To,
The Commisioner,
Bruhat Bengaluru Mahanagara Palike,
Bangalore

Re: Pedestrian Underpass Design

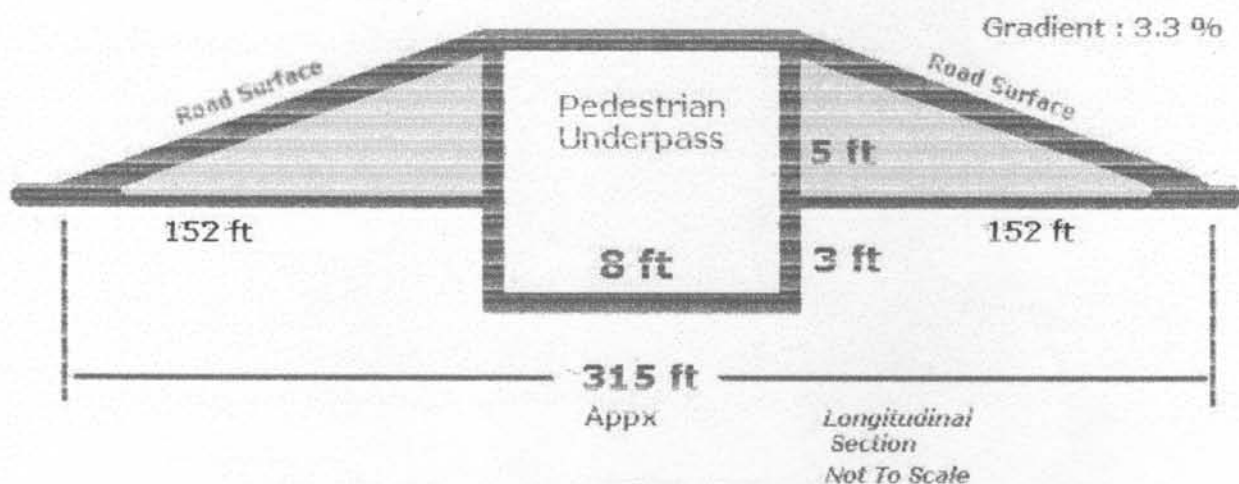
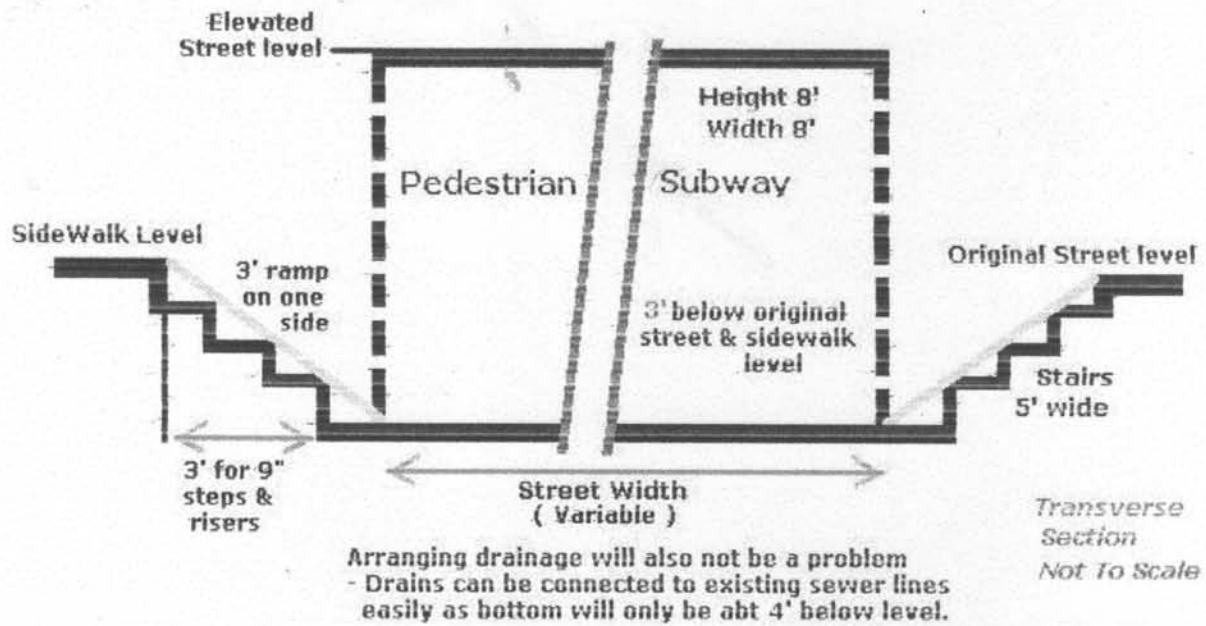
I came across a few pedestrian subways in Mumbai & also in some Chinese cities where the subway is sub-sunk by a few feet & the road is elevated over it. This is much easier for pedestrians & utilization is greatly improved as there are only a few steps to negotiate, instead of going down one full level. The two diagrams below illustrate this design :

The edges of the elevated roads were finished with solid, vertical retainer walls & the sloped road surfaces had no signs of any caving in. In Mumbai, these are fitted along the western & eastern express highways, catering to heavy trucks & buses. They had obviously compacted the earth below fully & then tarred the surface. Sufficiently high medians & walls along the length of the sloped section of the road were installed, thus preventing jay-walking & making it safe for all.

I believe that if designs that minimize inconveniences for pedestrians are used, such as the one above, the utilization of pedestrian subways will be far better than with the ones being fitted now, which are fully "buried" below the road surface.

I request you to please consider this suggestion for revising the design for pedestrian subways to ease pedestrians' woes & to see better utilization & safety on the streets.
